**Expert Assessment of the Static Recalculation of the Bridge
“SO-20-20-05 Railway Bridge at km 3.706 – Pod Vyšehradem”**

Prepared by: **prof. Ing. Josef Vičan, CSc.**
 Ing. Jaroslav Odrobiňák, PhD.
 Ing. Jozef Gocál, PhD.

Žilina 08/2018

Fig. 4.1 Simplified application of wind loads to a steel load-bearing structure

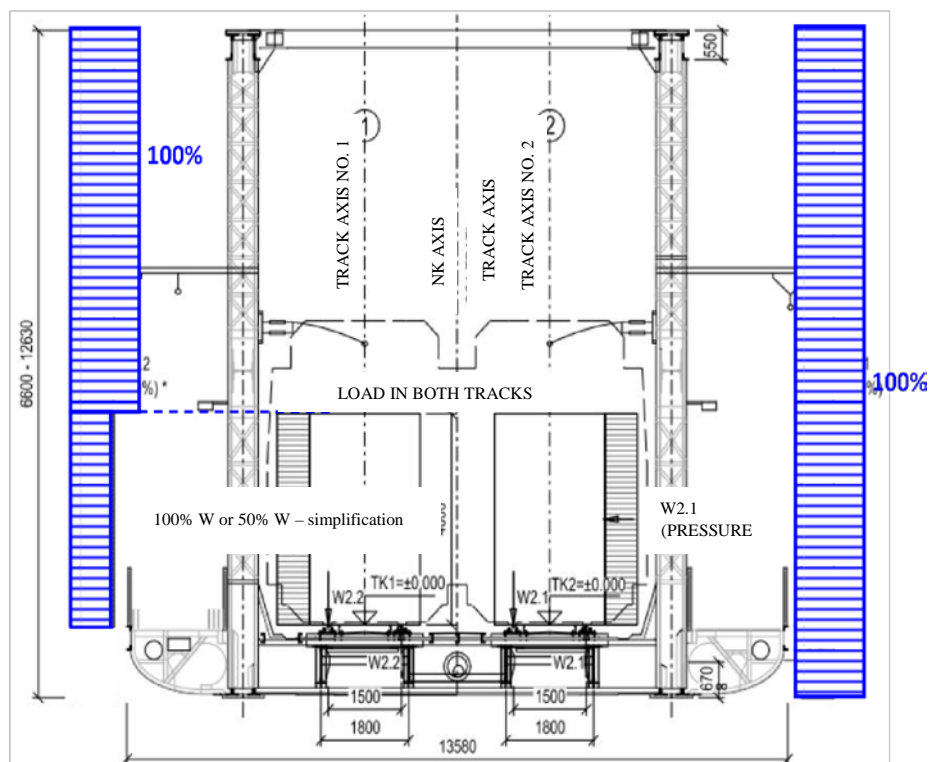
- b) The considered wind load on the windward beam of 100% and on the outermost beam only 50% is contrary to the Standard [16]. While this simplification has a realistic basis, it should have been applied only up to the amount of traffic load. Thus, from a height of 4.0 m from the top of the rails it is necessary to load both main beams with the full wind load (see figure below). At the same time, according to [16], it is possible to consider the wind load on the rail-track only on the windward beam. The eccentricity of the action of the horizontal component of the wind load on the web of the moving load should be correctly considered from the plane of the rail-track stiffening. This also applies to side impact loading.
